Response to Reviewer 1

Figure xxx: Statistical result of the relative power between the mainlobe and sidelobe for eight ship clutter events with high SNR.

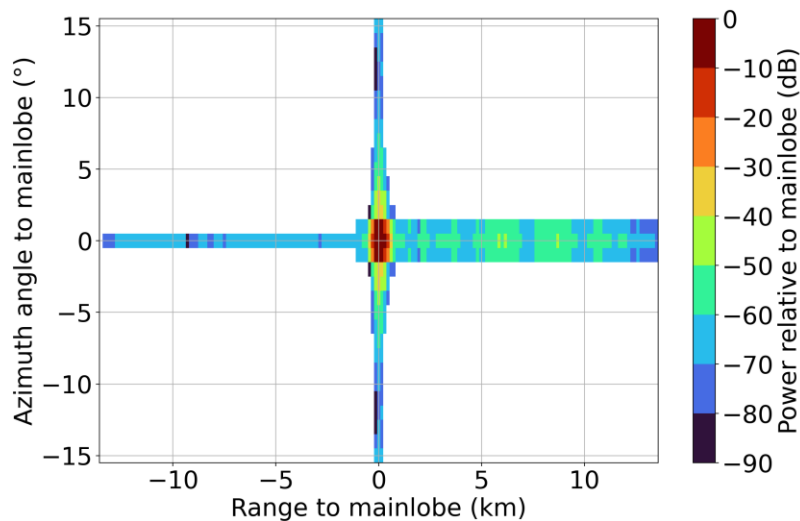
Suggest clarifying briefly why re-estimating sidelobe power relationships was necessary for the NLFM case. Was this driven by waveform differences that significantly impact sidelobe structure?

Agree. As correctly understood by the reviewer, the LFM and NLFM waveforms of the Kumpula radar exhibit different sidelobe structures (the relative power relationship between the mainlobe and sidelobes of the NLFM waveform is illustrated in the figure below). Accordingly, the revised manuscript includes the following clarification: "It is worth noting that the mainlobe identification employed the same random forest model as that used for the LFM waveform. However, the relative power relationship between the mainlobe and sidelobes was re-estimated based on observations under the NLFM waveform, primarily due to the different sidelobe structures of the two waveforms."

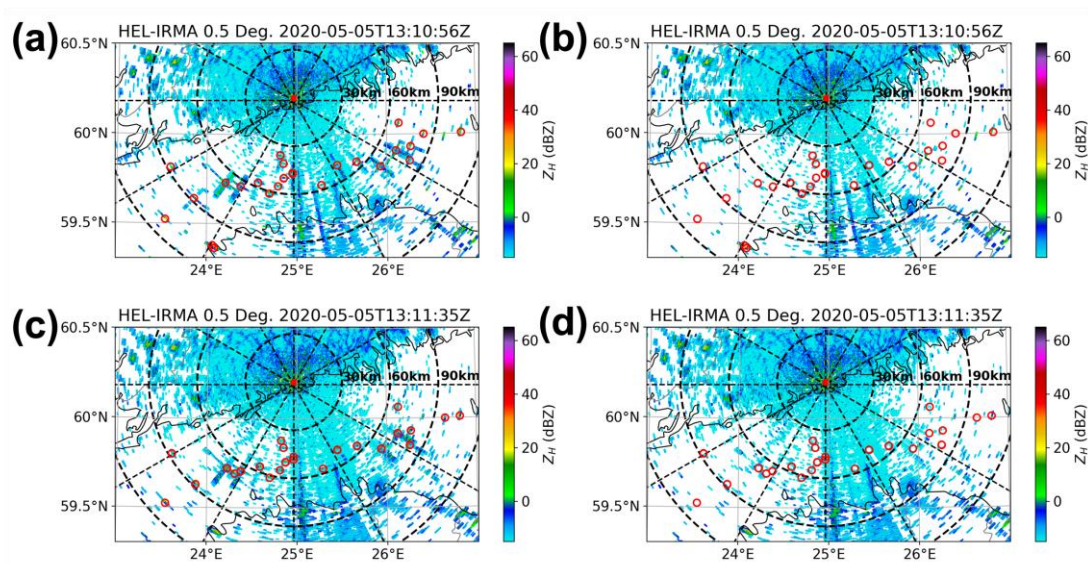
Question 3: Figure 11 (Page 17):

Recommend increasing the contrast or changing the color of the circles identifying the clutter mainlobes, as they are not easily distinguishable on some background echoes.

We attempted to replace the circle color with other options, but none proved to be more distinguishable against the light-colored background. Although black offers good contrast, it is already used in the figure to draw the range rings and radial lines for spatial reference. Therefore, we chose to thicken the red circles and submitted the high-resolution figure as an attachment, allowing readers to zoom in for better visibility while maintaining sufficient clarity.
